SUBJECT: Forwards response to 831205 request for addl info re
 NUREG-0737 Item II.D.1, "Performance Testing of Relief &
 Safety Valves." Microfiche of RELAPS/ADLPIPE computer
 analyses encl.

Docket 50-305
 Operating License DPR-43
 Kewaunee Nuclear Power Plant
 NUREG-0737, Item II.D.1 "Performance Testing of Relief
 and Safety Valves" Request for Additional Information

REQUEST FOR ADDITIONAL INFORMATION
TMI ACTION NUREG-737 (II.D.1)
RELIEF AND SAFETY VALVE TESTING
FOR
KEWAUNEE

FIGURE A6-1

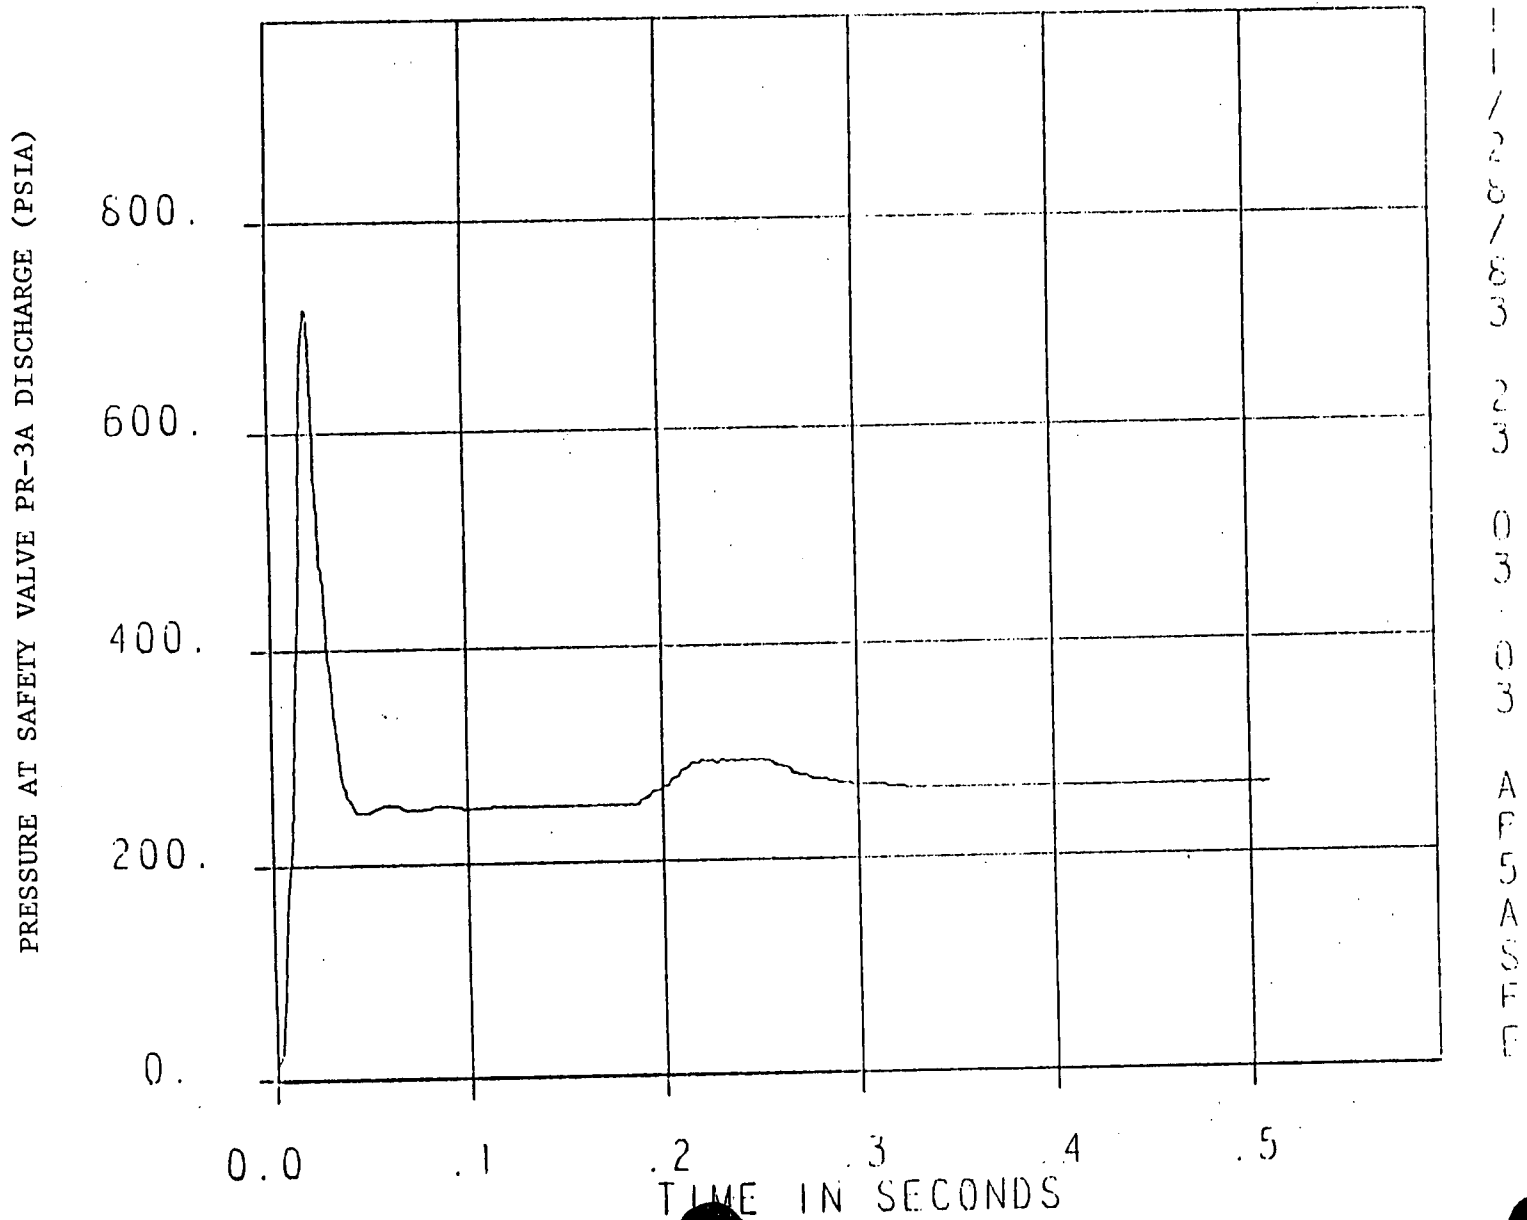
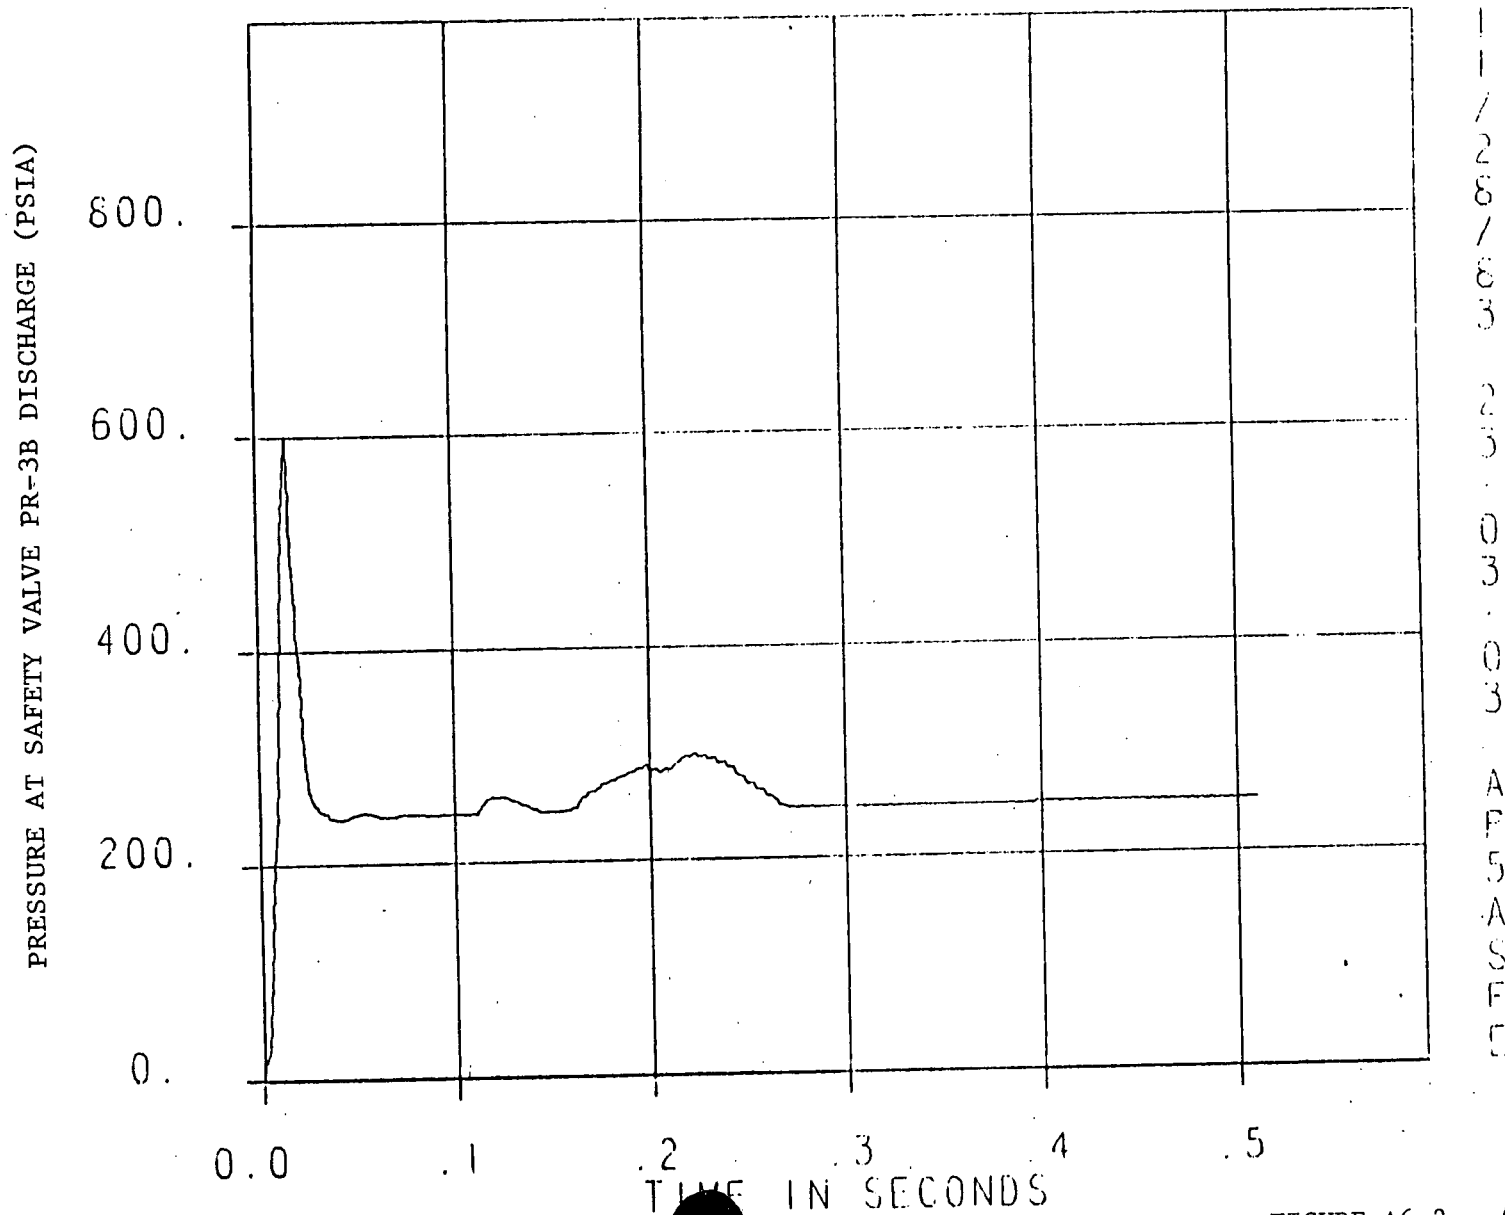
Q-6. The submittal indicates that there is some difference between ring settings used in the Electric Power Research Institute (EPRI) Crosby safety valve tests and those used at the plant and, for the same flow rate, the plant backpressure is greater than was tested. An evaluation should be presented that shows that the plant valves will pass rated flow capacity with the ring settings used at the plant together with expected backpressures.

Q-11. The backpressure measured during the tests should be representative of the plant backpressure since the valve performance is affected by the backpressure. The thermal hydraulic analysis on the loop seal-steam flow actuation condition yielded peak backpressure of 792 psi while the backpressure of 649 psi was measured during the corresponding test 908. While the submittal states that the tested and plant specific backpressure are very close, some justification should be provided that these pressure values are indeed sufficiently close that actual conditions were truly represented in the tests.

The backpressures presented in Reference 1 are the peak backpressures. The C-E tested flow rates for the Crosby safety valves were measured at steady state backpressures. The peak and steady state backpressures calculated for the Kewaunee S/RV discharge piping at the exits of safety valves, PR-3A and PR-3B are shown in Figures A6-1 and A6-2, respectively. These are calculated for the double rupture disc configuration as shown on Figure A23-1. As seen in Figure A6-1 and A6-2, the peak backpressure was calculated for safety valve PR-3A at 716 psia and the steady state backpressure was calculated to be approximately 245 psia. This steady backpressure is greater than the steady state backpressures measured for the C-E Crosby safety valve testing for high backpressure.

A-11. With the modification of the Kewaunee S/RV discharge piping, to include the rupture disc and baffle plate assemblies, the peak backpressures were reduced significantly. As stated on A-6 of these responses and shown in Figures A6-1 and A6-2, the peak backpressures were calculated by RELAP5 to be 716 psia and 600 psia for Kewaunee safety valves, PR-3A and PR-3B, respectively. The peak backpressure measured for the Crosby 6M6 safety valve testing was 725 for CE Test 931 which exceeds the peak backpressure calculated for the Kewaunee valves. Therefore, the Kewaunee safety valves were bounded by the test program.
